Moorebank

23-29 Harvey Ave, MOOREBANK

S4.55

COVER SHEET

BASEM	IENT 2		
PROJECT NO.	DRAWING NO.	REVISION	DATE
21-038	DA-0-209	F	29/08/2022
SCALE @ A3		DRAWN	AUTHORISED
1:200		OP	FC
0	SCALE	1:200	10m

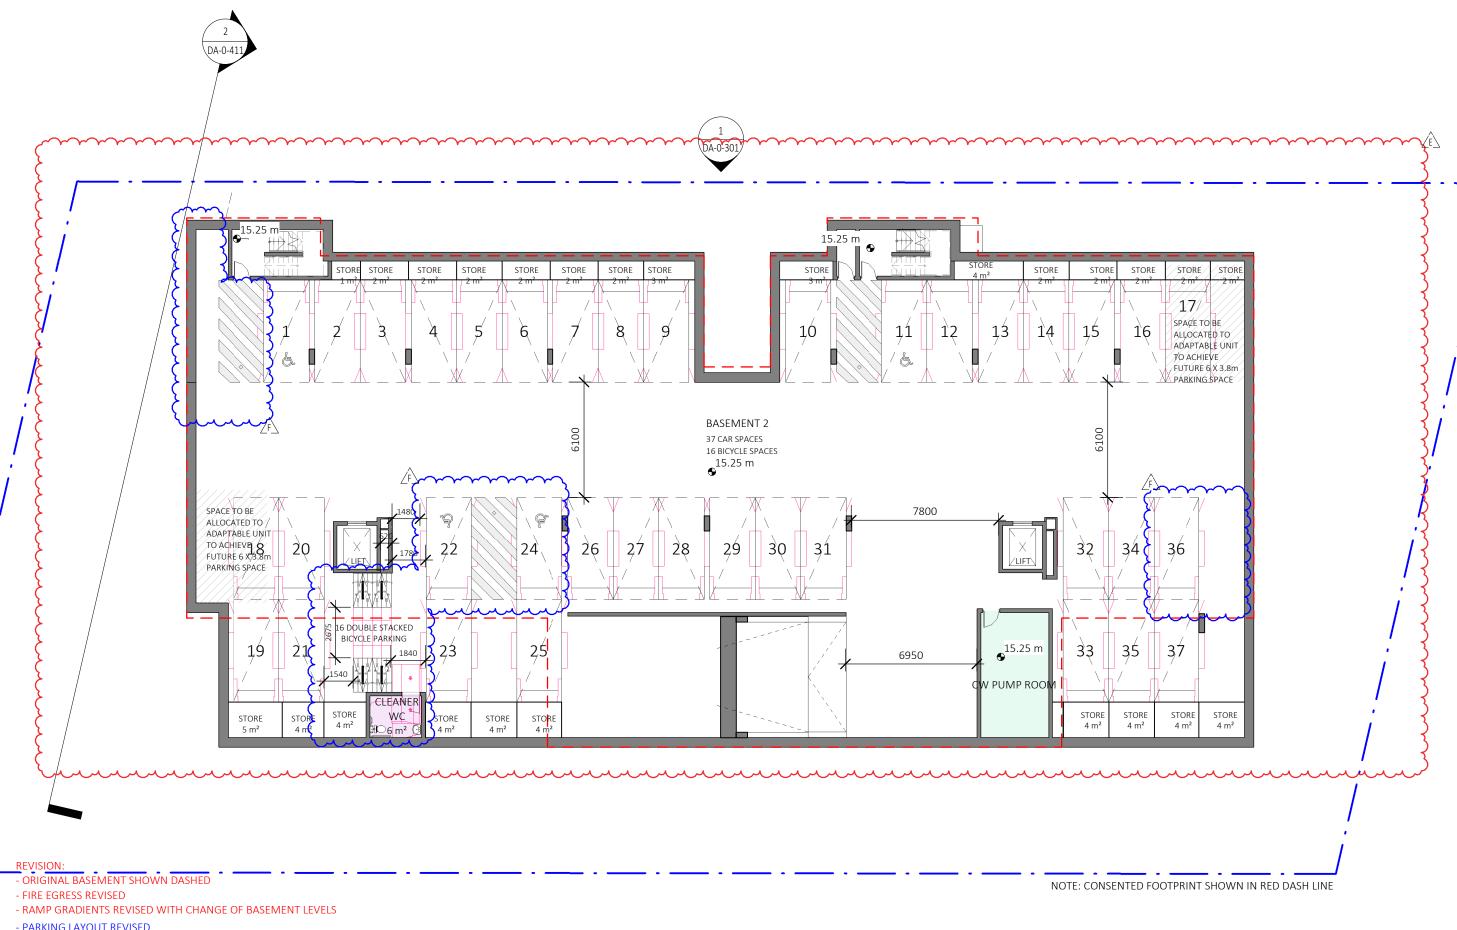
- PARKING LAYOUT REVISED
- CLEANER WC RELOCATED

BASEM	ENT 1		
PROJECT NO. 21-038	DRAWING NO.	REVISION F	DATE 29/08/2022
SCALE @ A3		DRAWN	AUTHORISED
1:200		OP	FC
0	SCALI	E 1:200	10m

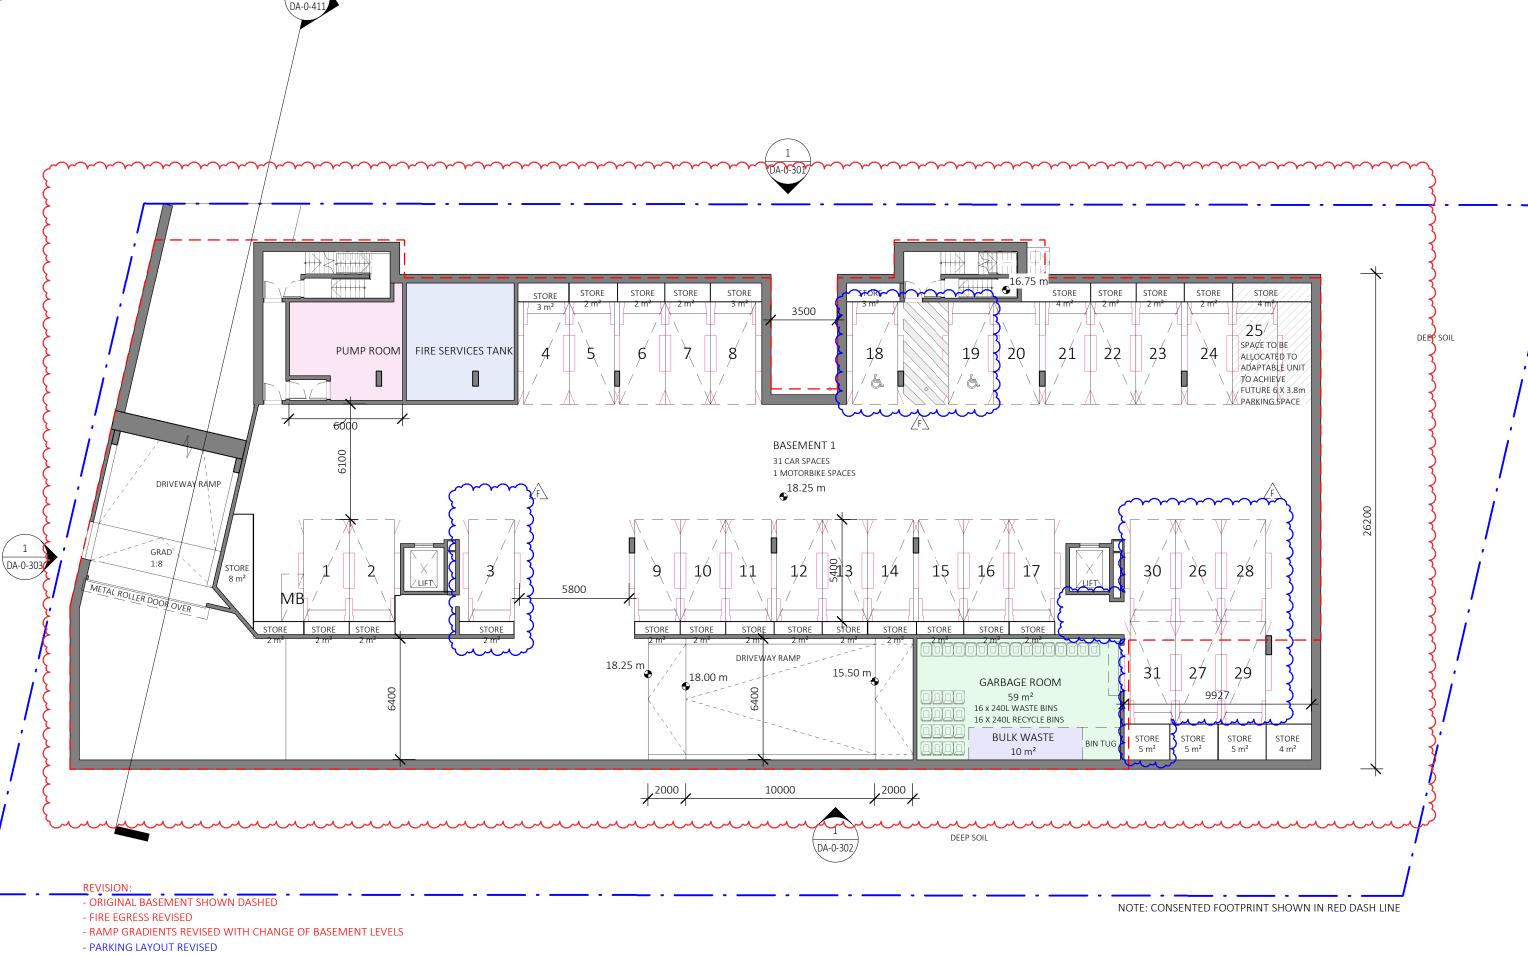
- CLEANER WC RELOCATED

LEVEL 1 FLOOR PLAN Moorebank 23-29 Harvey Ave, MOOREBANK

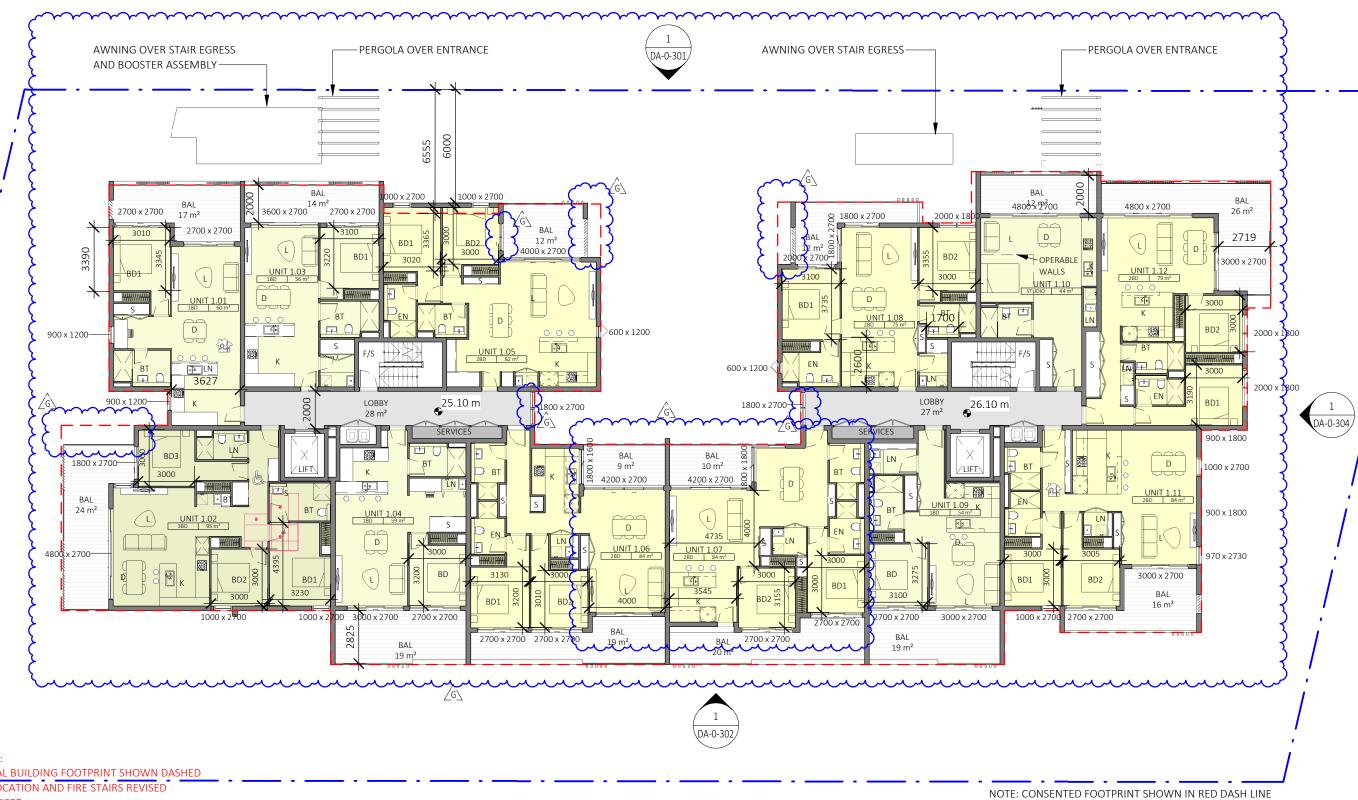
- ORIGINAL BUILDING FOOTPRINT SHOWN DASHED

- CORE LOCATION AND FIRE STAIRS REVISED
- WINDOWS ADDED TO LOBBY
- DOOR ADDED TO UNIT 1.05 BALCONY
- ADDED BEDROOM DIMENSIONS
- UNIT LAYOUTS AND BALCONY REVISED

LEVEL 2 FLOOR PLAN

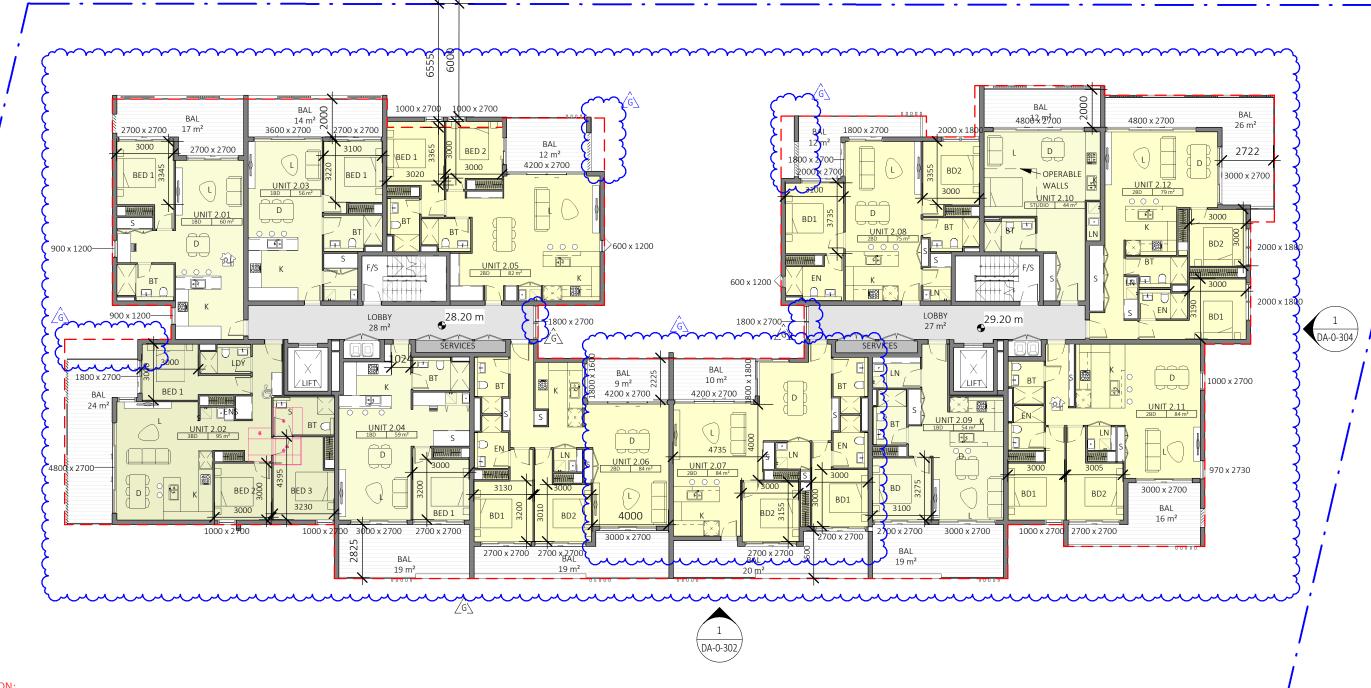
- ORIGINAL BUILDING FOOTPRINT SHOWN DASHED
- CORE LOCATION AND FIRE STAIRS REVISED
- RL'S REVISED
- WINDOWS ADDED TO LOBBY
- ADDED BEDROOM DIMENSIONS
- UNIT LAYOUTS AND BALCONY REVISED

LEVEL 4 FLOOR PLAN

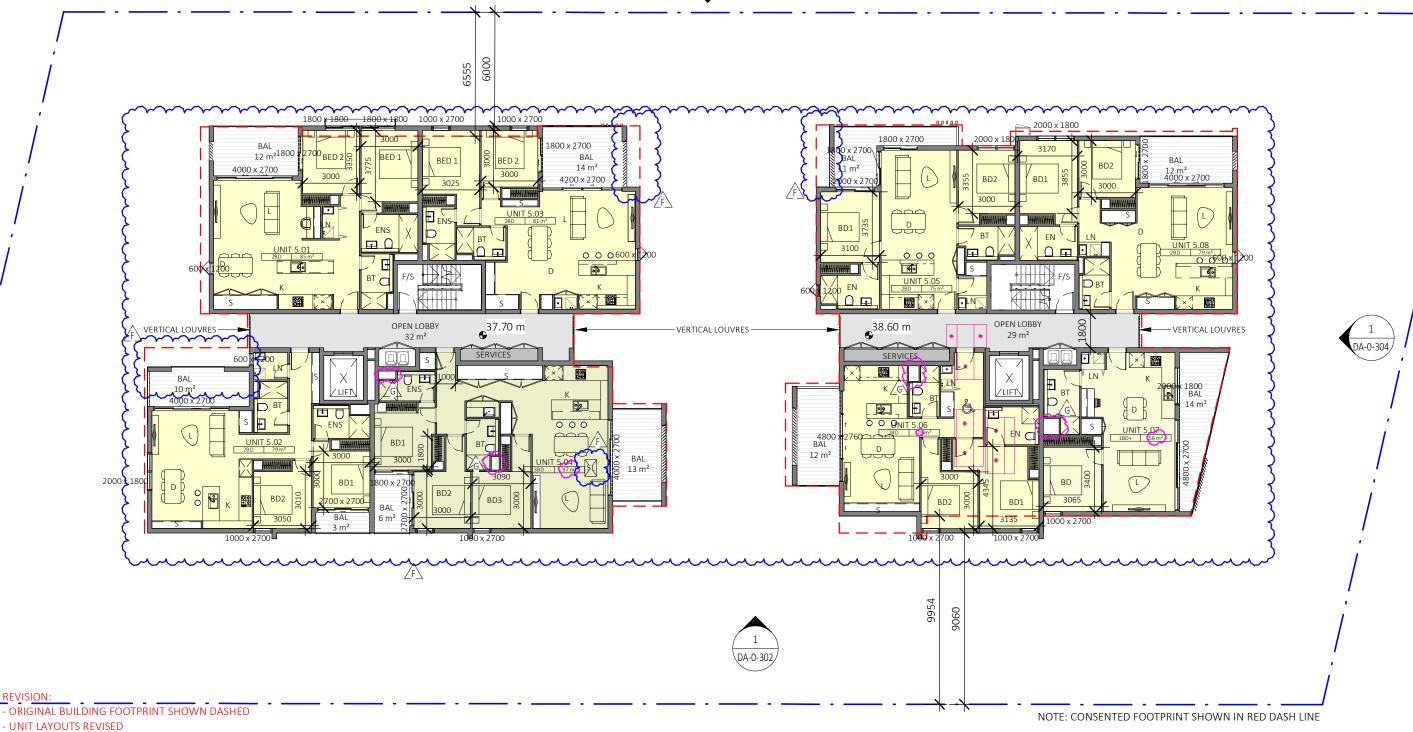
- CORE LOCATION AND FIRE STAIRS REVISED
- RL'S REVISED
- ADDED BEDROOM DIMENSIONS - ADDED SKYLIGHT TO UNIT 5.04 - RISERS AND AREAS ADJUSTED

- BALCONY REVISED

LEVEL 5 FLOOR PLAN

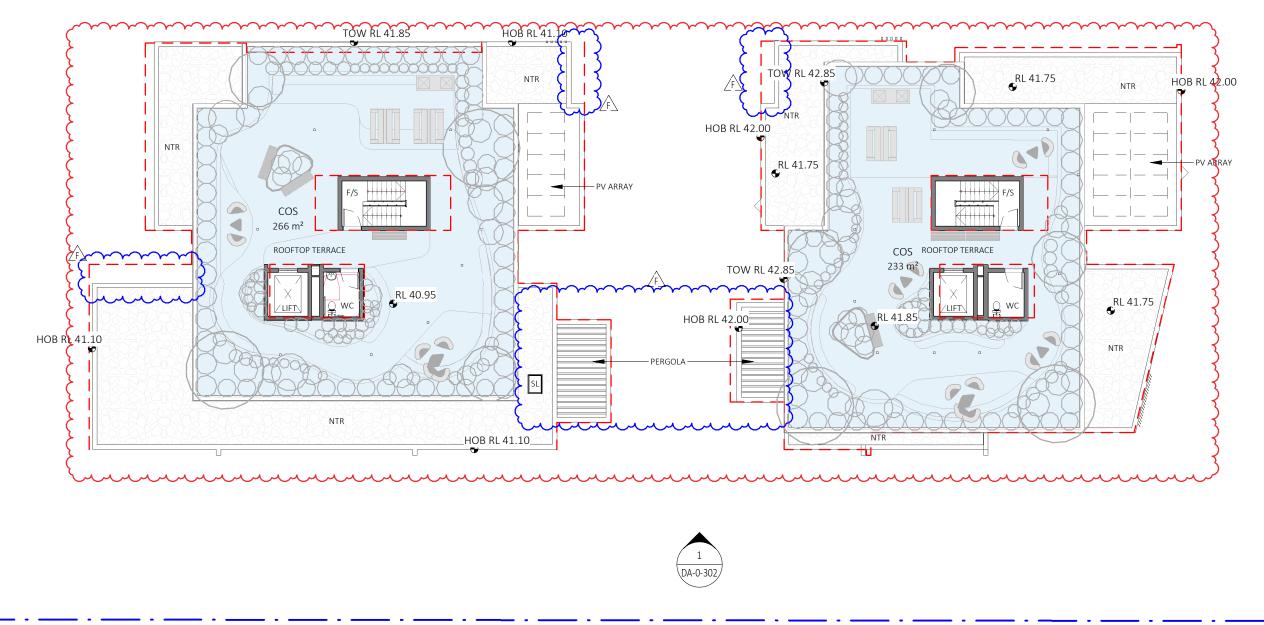
- ORIGINAL BUILDING FOOTPRINT SHOWN DASHED
- CORE LOCATION AND FIRE STAIRS REVISED
- ROOFTOP WC REVISED
- PV ARRAY LOCATION SHOWN
- RL'S REVISED

- ADDED SKYLIGHT TO UNIT 5.04

- ADDED PERGOLA TO BALCONY

COMMUNAL OPEN SPACE PLAN

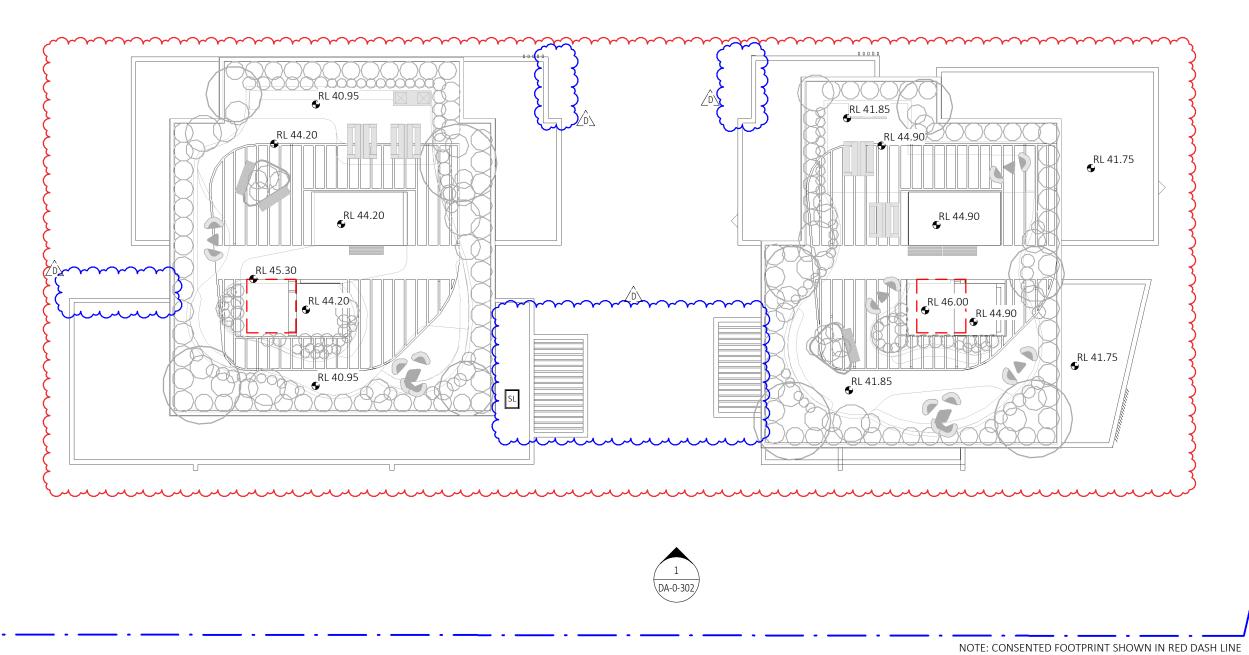
- RL'S REVISED

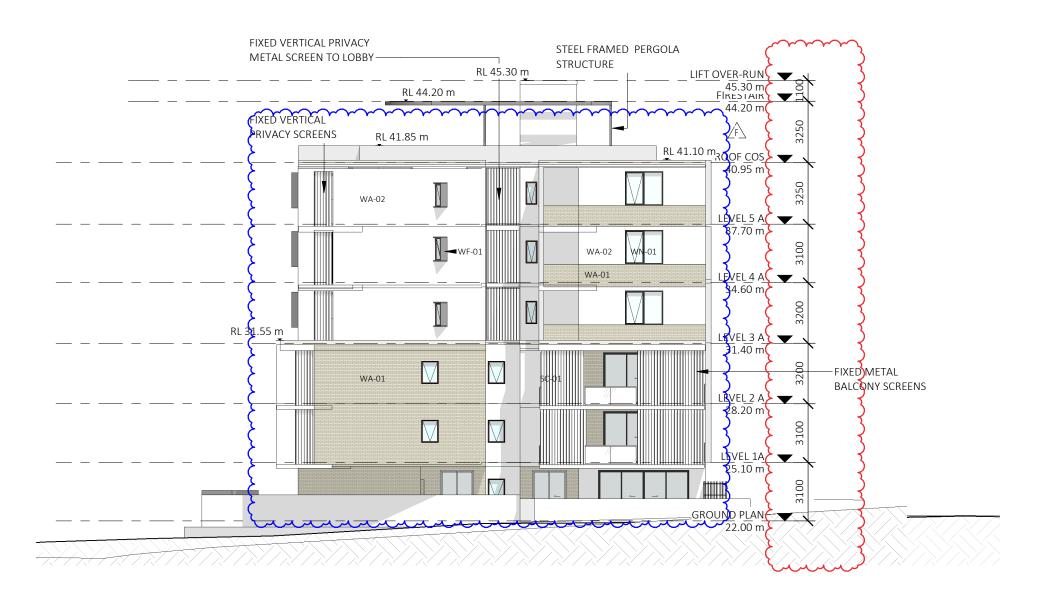
- FLOOR TO FLOOR LEVELS INCREASED FROM 3050 TO AT LEAST 3100
- MATERIALS REVISED

WEST ELEVATION

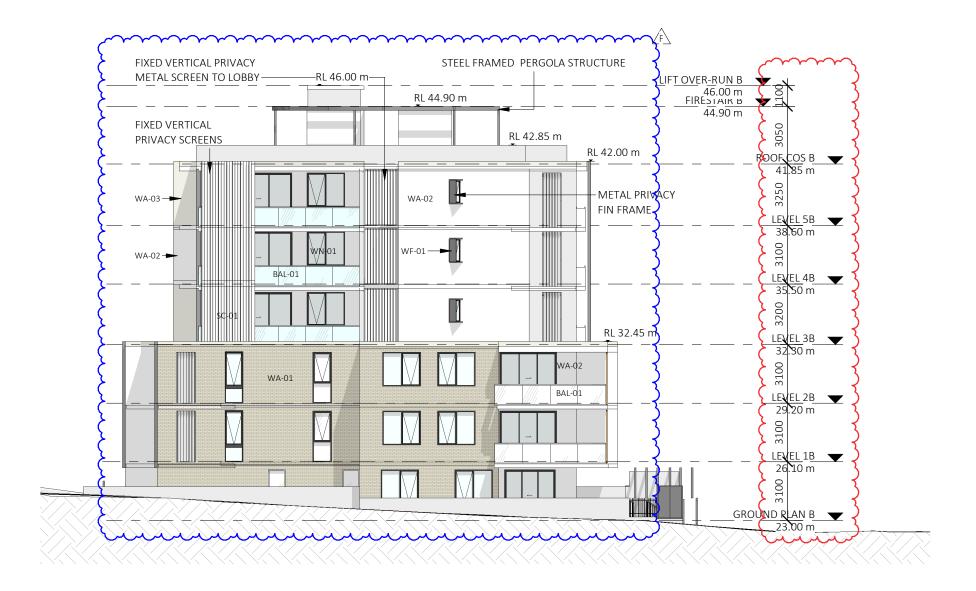
- FLOOR TO FLOOR LEVELS INCREASED FROM 3050 TO AT LEAST 3100
- MATERIALS REVISED

G02, 102, 202 Pre-Adaptable DA-0-301/1:100

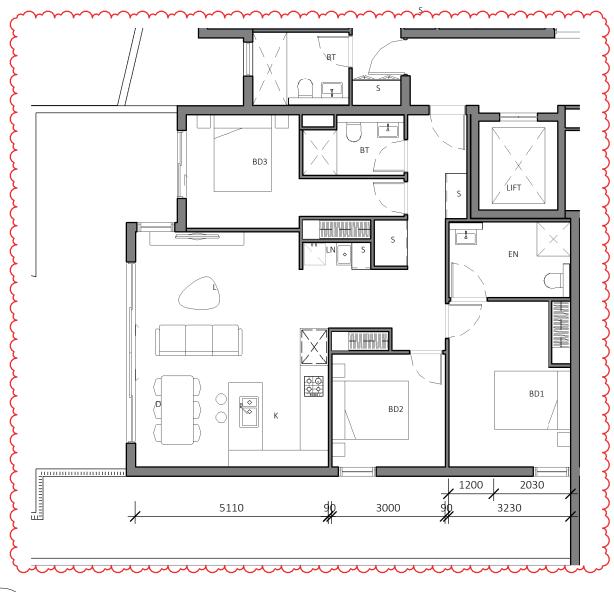
- PRE AND POST ADAPTABLE UNIT LAYOUTS REVISED

101, 201 Livable Unit \DA-0-301 \1:100

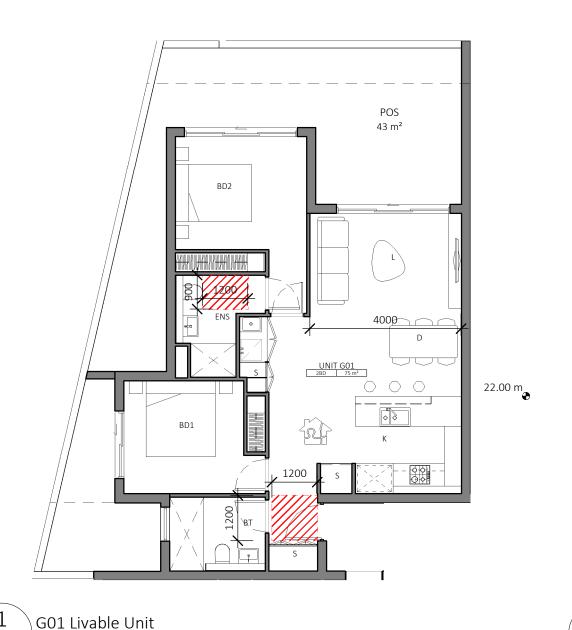
- NEW DRAWING
